ADDENDUM NO. 4

Reference: Gibson Science Center Addition
Southern Utah University – Cedar City, Utah
DFCM Project No. 07297730

Subject: **Addendum No. 4**

Sheet No.
AD04-M04
 Sheet Reference
 MH102

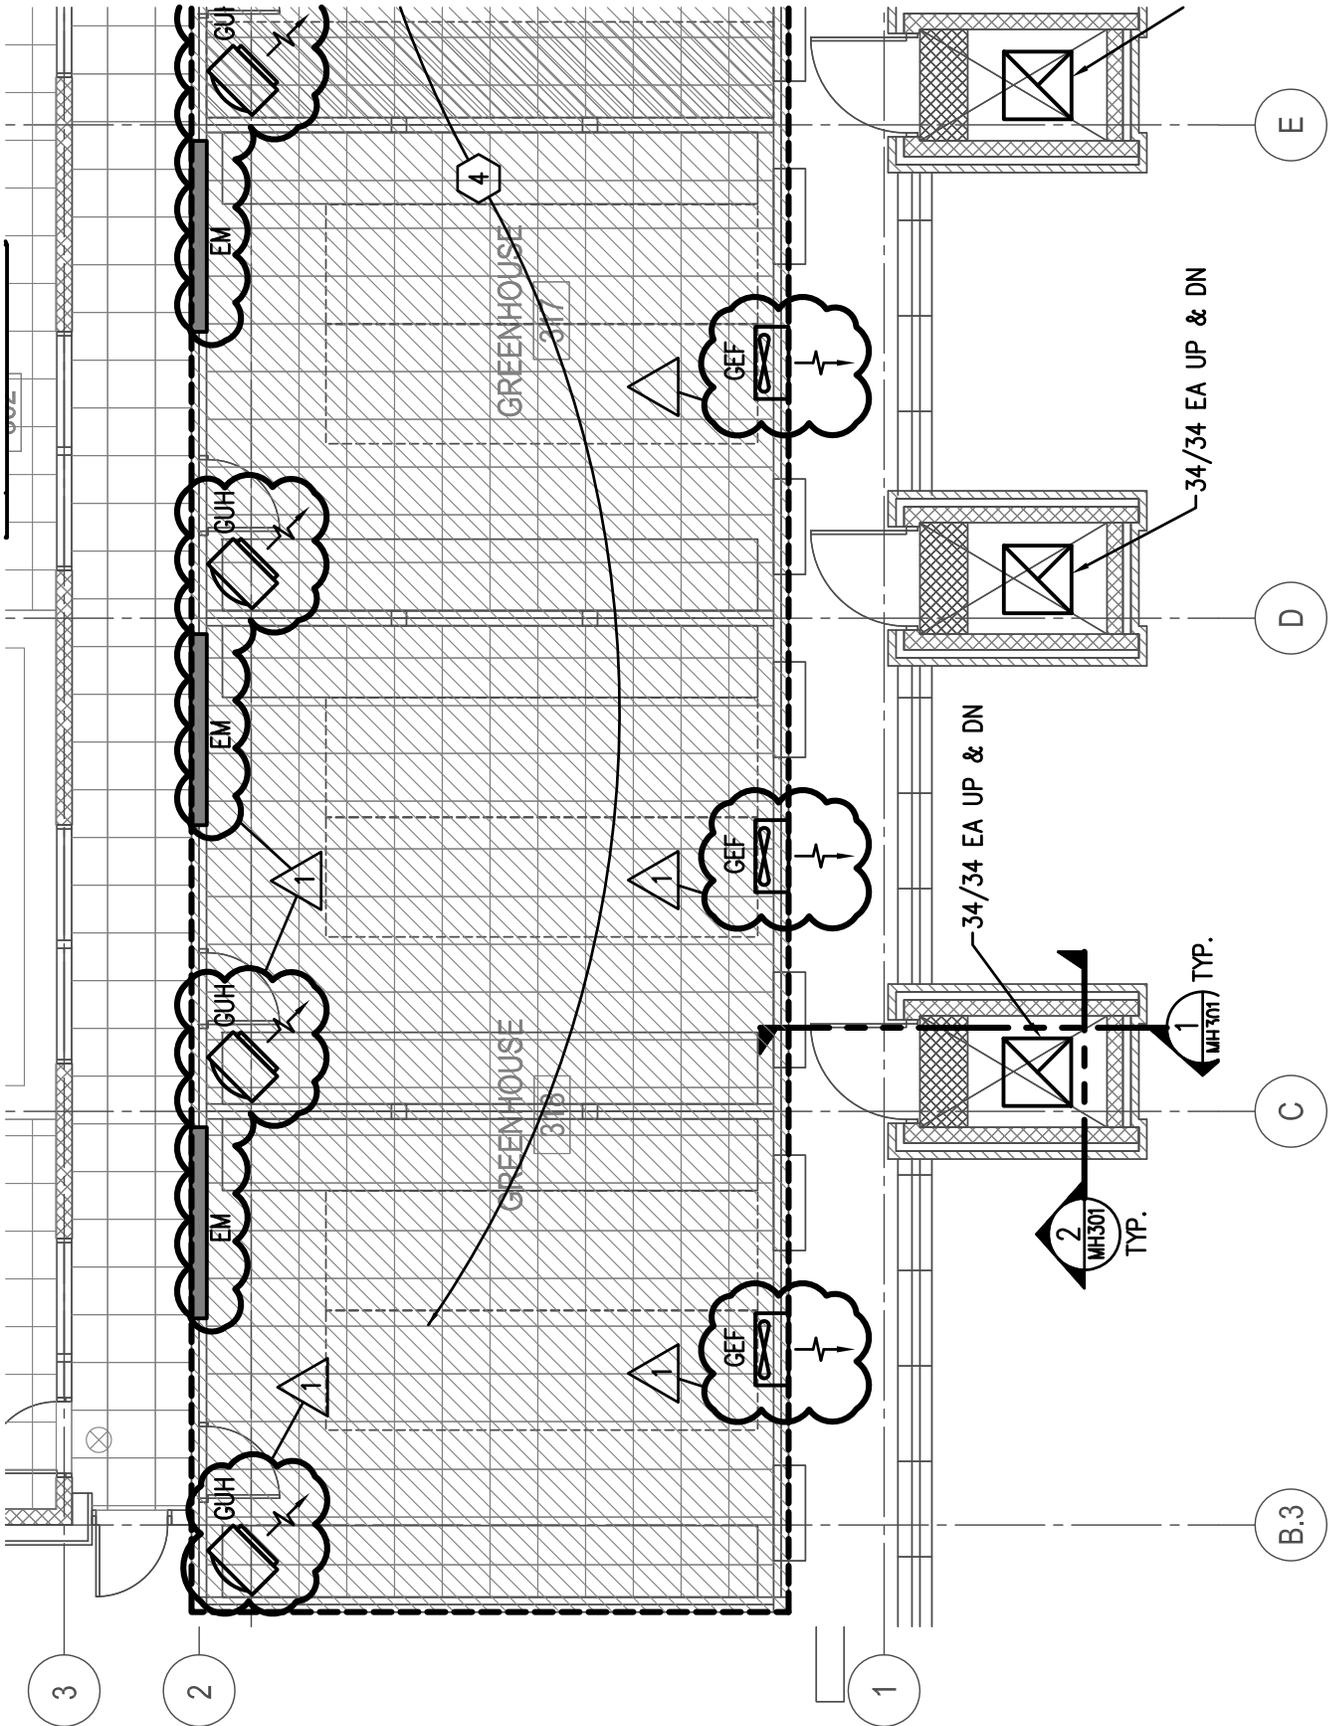
- M1.12** Re: MH102: Modified ductwork into exhaust shaft, duct routing. See ADO4-M04.
- M1.13** Re: MH103: Added equipment layout and notes in greenhouse. See ADO4-M05&6.

MH602

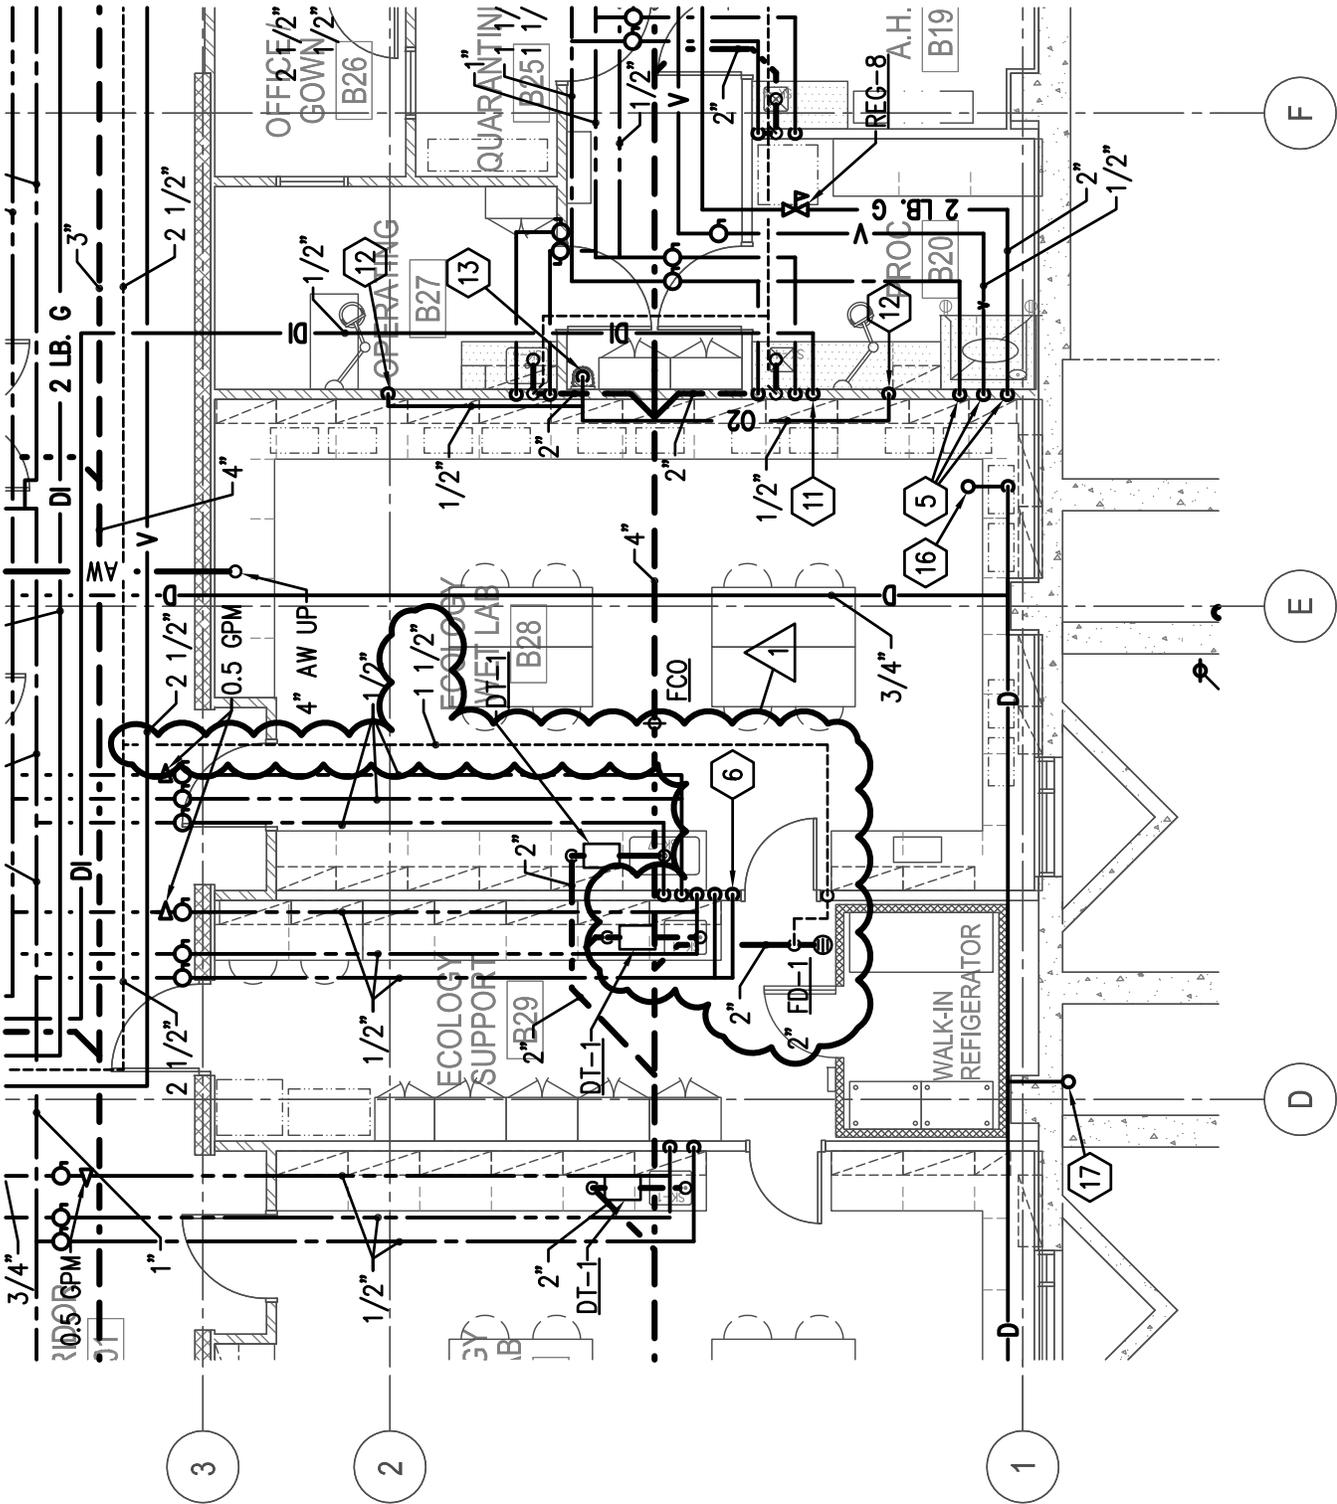
- M1.24** Re: MH602: Added control valve schedule. See ADO4-M24.
